Subject: Grand Gulf Nuclear Station  
Docket No. 50-416  
License No. NPF-29  
Response to Generic Letter 95-07  
Request for Additional Information

GNRO-96/ 00078

Response to NRC Request for Additional Information  
Generic Letter 95-07

FIGURE 1

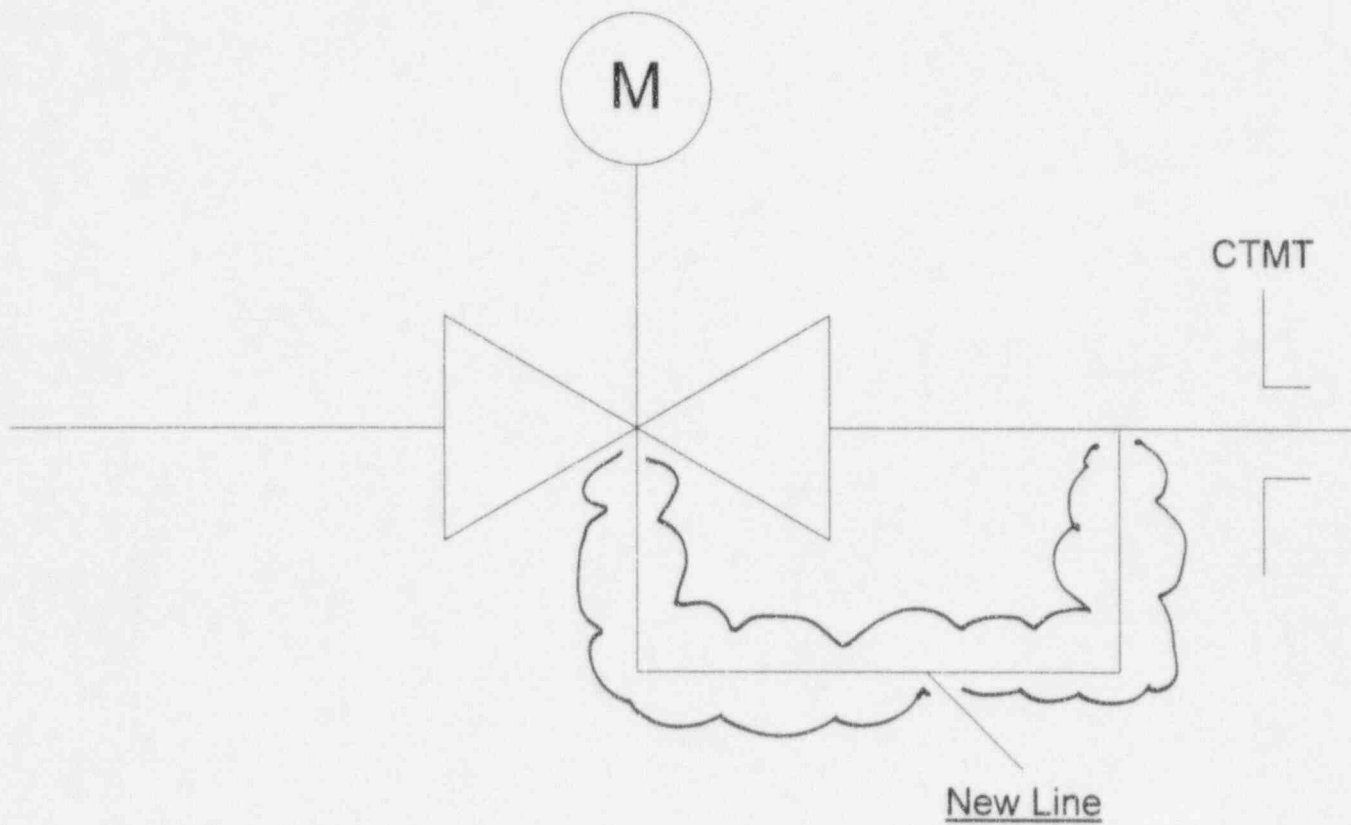
Describe the evaluations and training for plant personnel that have been or will be conducted for each valve design or procedural modification (to preclude pressure locking or thermal binding) to assure that the modifications will not have an adverse impact on plant safety.

The valve modifications to susceptible valves, including those already modified and those planned, involve providing a vent path from the bonnet area back to the system piping to prevent pressure locking (Figure 1). These modifications result in one side of the double disk performing the isolation function for the valve.

The loss of one side of valve disk is considered for impact on the plant. To ensure that the modifications did not, or will not, have an adverse impact on plant safety, evaluations were performed for each of the changes in accordance with 10CFR50.59. Post modification testing, including Local Leak Rate Testing, confirms the acceptability of the change. The fact the valves would become unidirectional was considered. For example, a manual valve was added in the vent line for the HPCS injection valve that is closed during the quarterly pump surveillance. This will prevent the injection of water into the vessel due to disc flexing from the pump discharge pressure during performance of this test.
